20-VARIANCE-0039

A&S Truck Road Services

Louisville Metro Board of Zoning Adjustment

Request

Proposed Site Plan

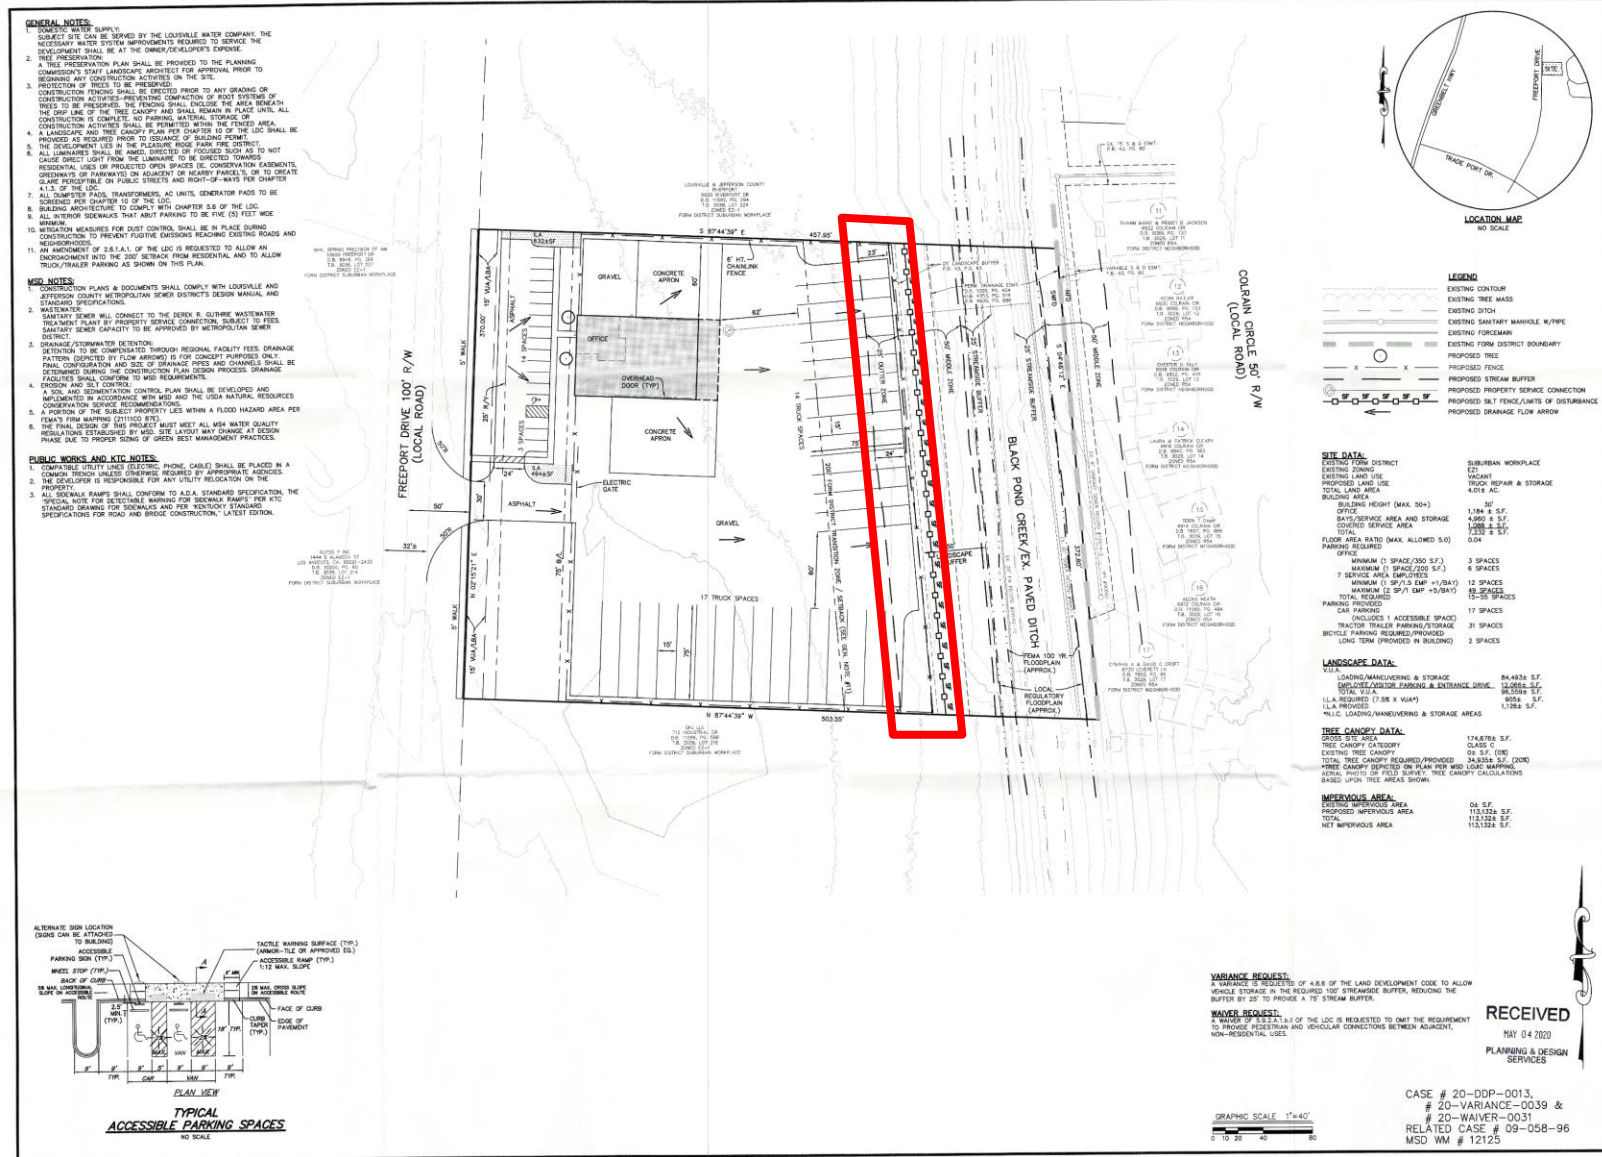
- **Variance** from table 4.8.1 to allow vehicular parking and maneuvering to encroach up to 25 feet into the 100-foot streamside buffer for Black Pond Creek.

- The request is adequately justified and meets the standard of review.
- Detailed District Development Plan and Waiver to not provide pedestrian/vehicular connection to adjacent sites was approved by Planning Commission 5-21-20 under docket 20-DDP-0013 and 20-WAIVER-0031.
